Department of Environmental Quality

**Table 1 – DEQ Split Event Comments**

**To:** Justin Sterger  
**From:** Shane Bennett  
**Subject:** Knife River Woodward Mine Split Field Report  
DEQ Laboratory Work Order 2512080

**Date:** 5 February 2026

Figure 5. Oxidation-reduction potential comparison between DEQ and the Contractor.

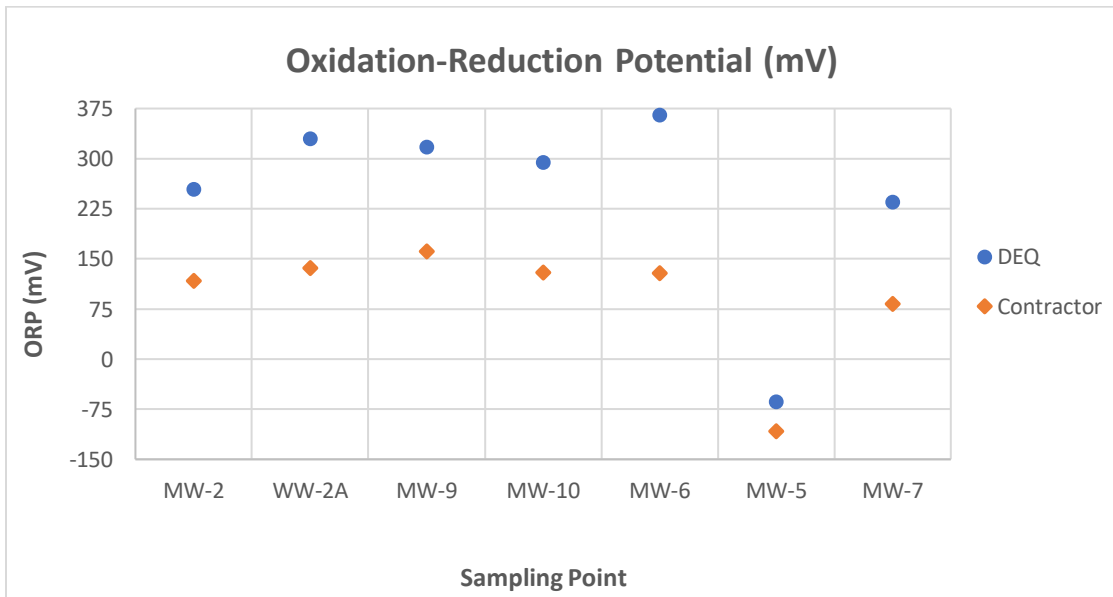
ORP readings had poor agreement with an average difference of ~155 mV and a maximum difference of 236 mV at MW-6. ORP is generally a qualitative field measurement and subject to interpretation based on the electrode types and environmental water chemistries. Large differences are not unusual. The data trended similarly to DEQ's meters and the differences grew smaller as readings approached 0 mV. The contractor's meter was tested in DEQ's calibration standard of 220 mV and was found to read 179 mV, well below the acceptable levels. All seven readings were biased low.

Figure 6. Turbidity comparison between DEQ and the Contractor.

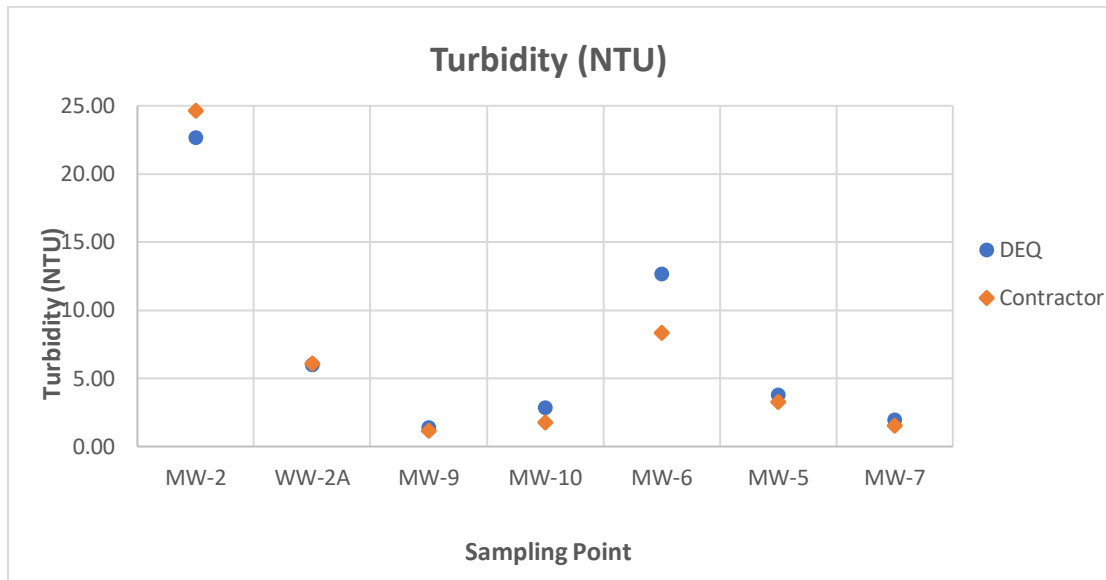
Turbidity readings had moderate agreement with an average difference of 1.24 NTU and a maximum difference of 4.34 at MW-6. The contractor's reading at MW-2 was taken by a ProDSS that did not stabilize reliably and would drastically change values at the slightest disturbance. Subsequent readings were taken by the Hach 2100Q turbidimeter.
